SUBFY2021-0010

Petra Point Subdivision

Common Open Space

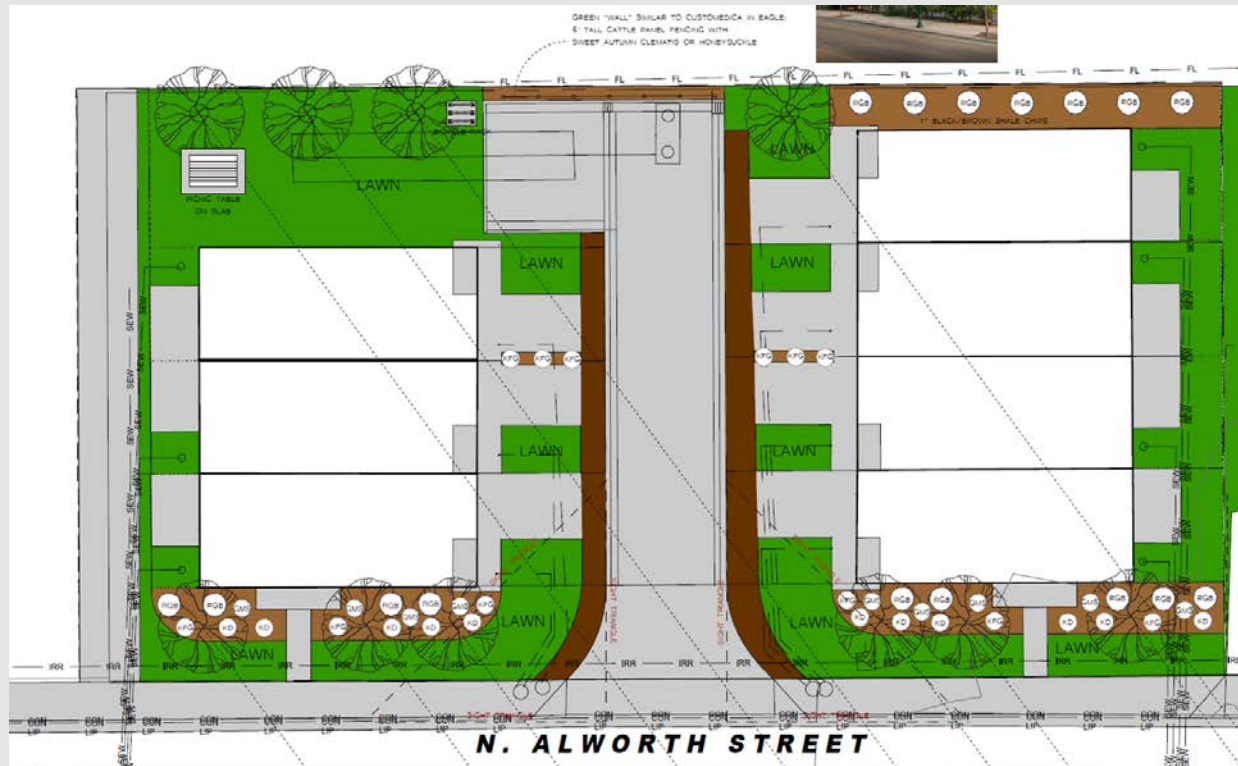
- Common open space has been provided, but square footage details have not been added to plans. Not enough information to review.
- Condition #7 & #2
